COLORADO
Division of Reclamation,
Mining and Safety
Department of Natural Resources

February 22, 2021

RE: Adequacy Review No. 2; 112c Construction Materials Amendment Application (AM-05), Pueblo East, Permit No. M-1986-015

AMENDMENT 4
PHASE 7 AREA

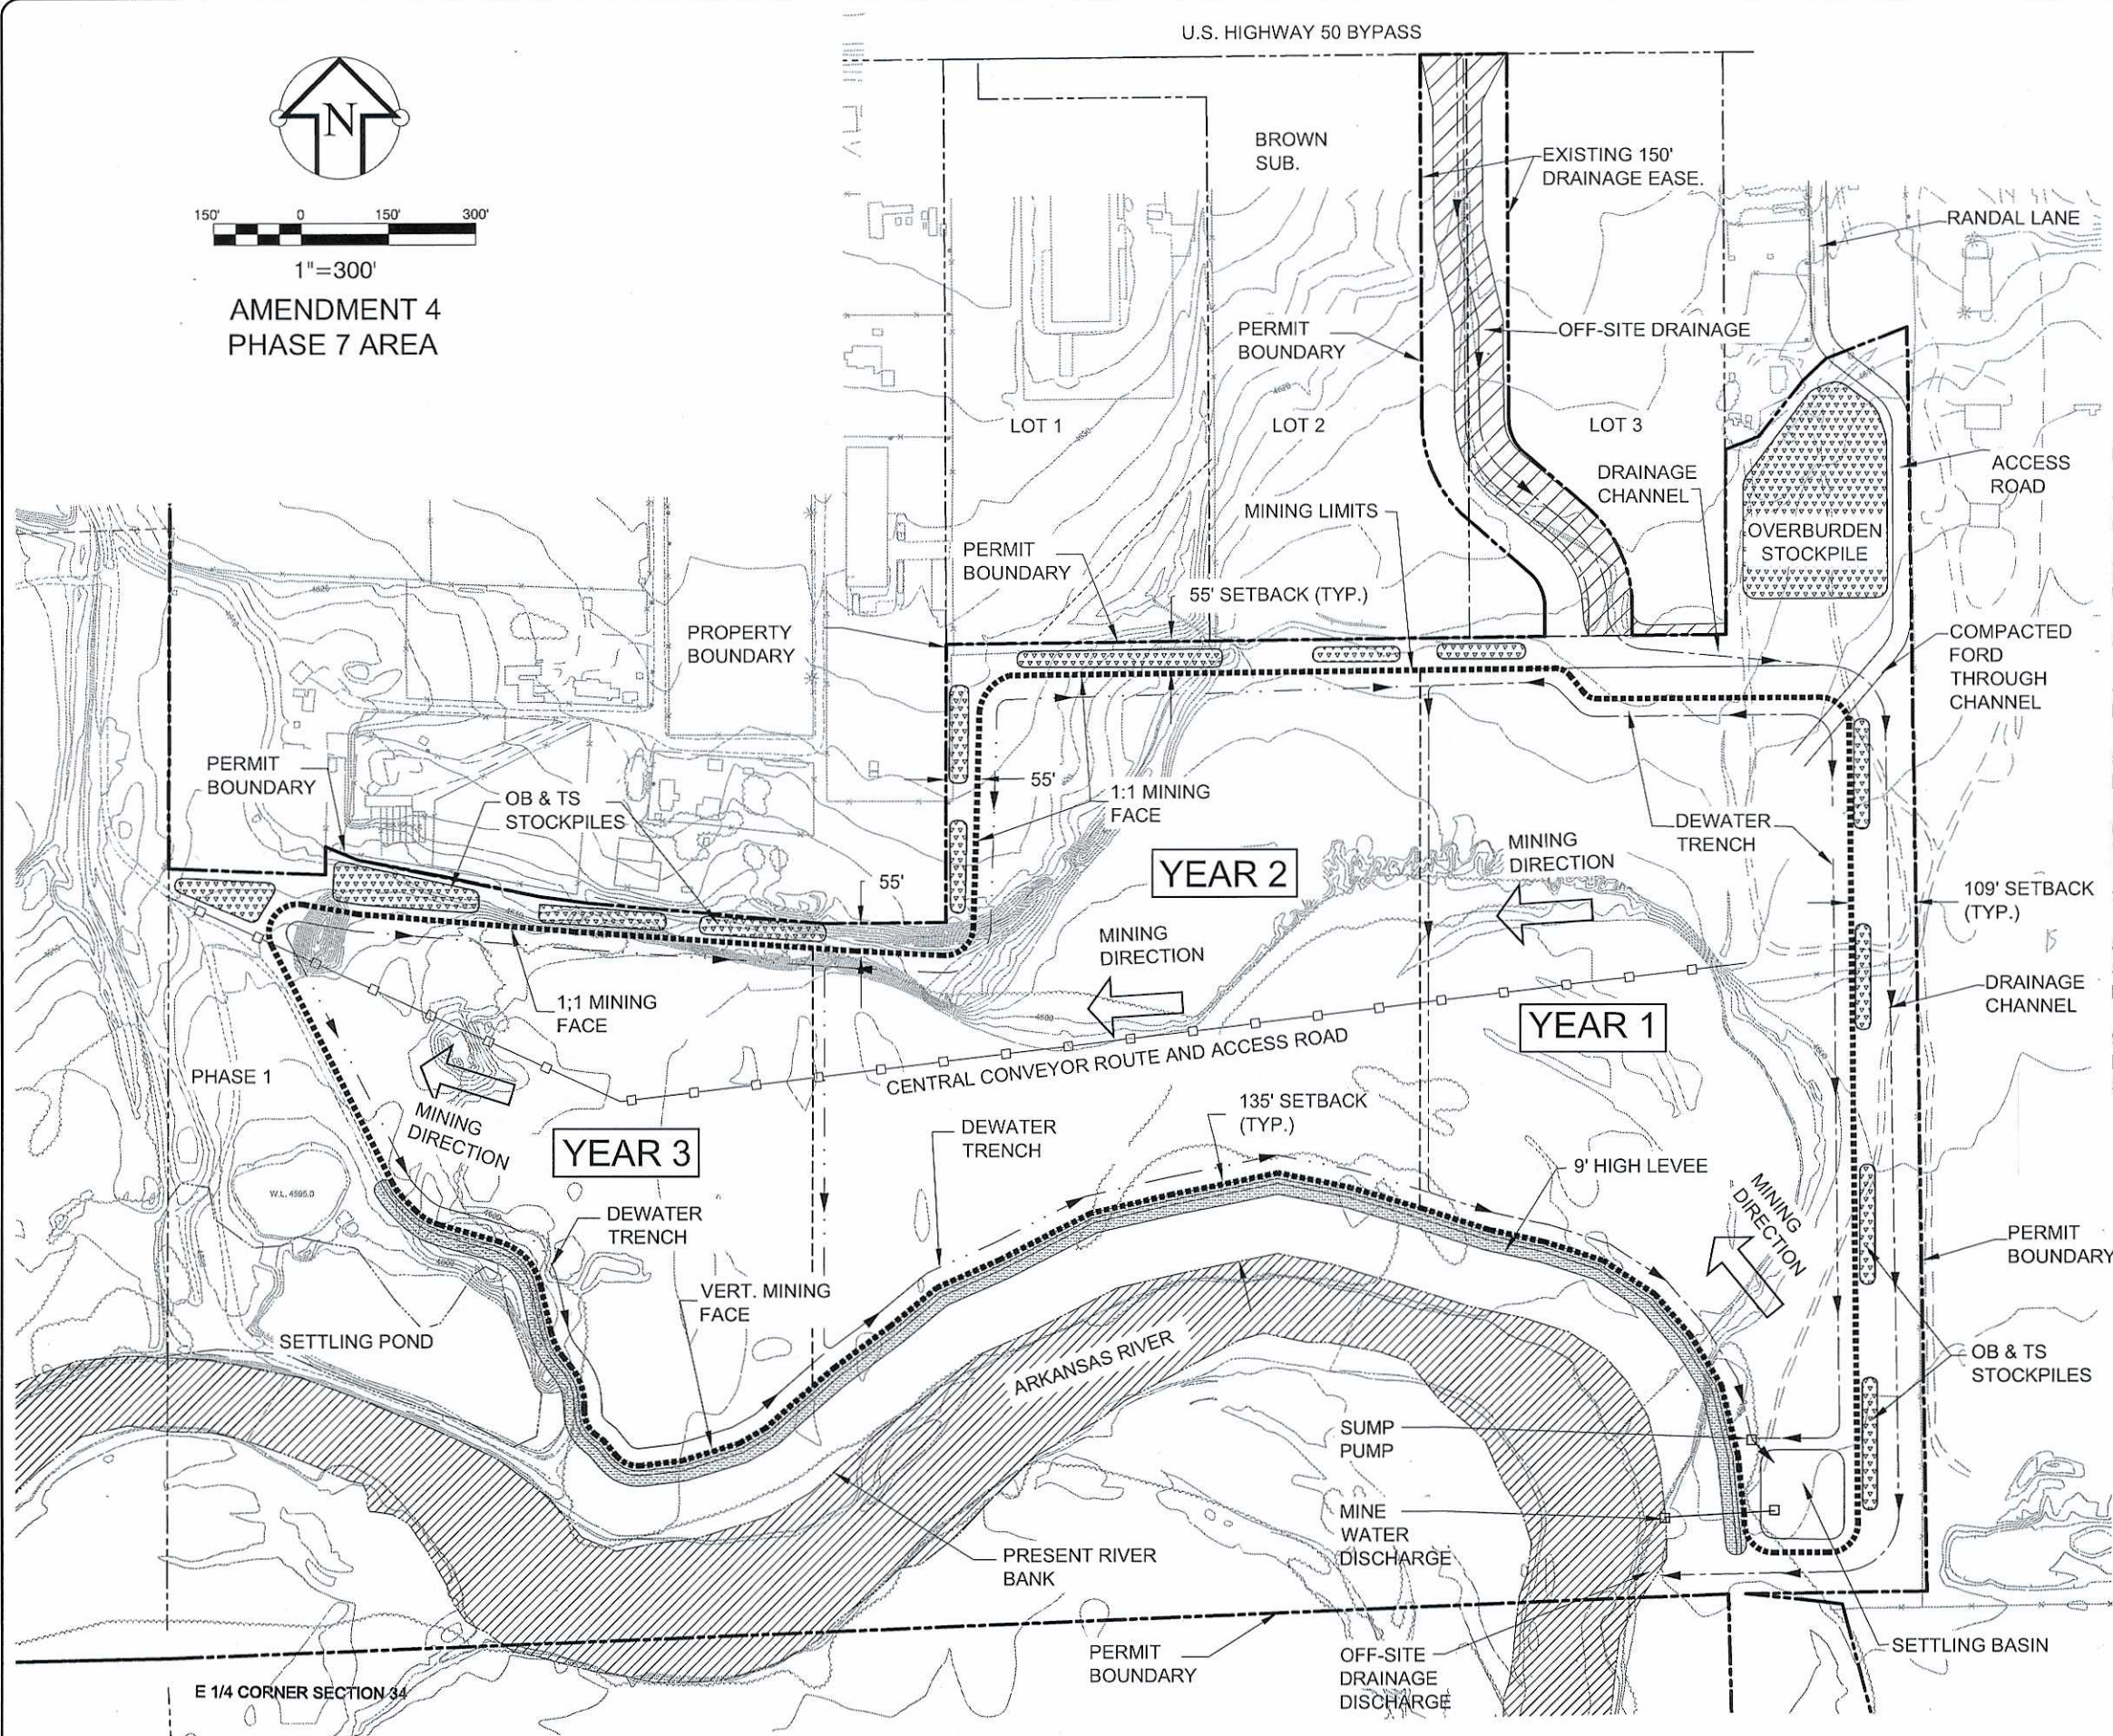
2. Please provide an updated Index Map that depicts the current approved permit boundary along with acreage. The map provided does not reflect acreage that was added to the permit in AM-01 to the southeast and the 28 acres that was added with the approval of AM-04 south of the Arkansas River. Attached to this review are the permit boundary maps from the four Amendments to help the operator.
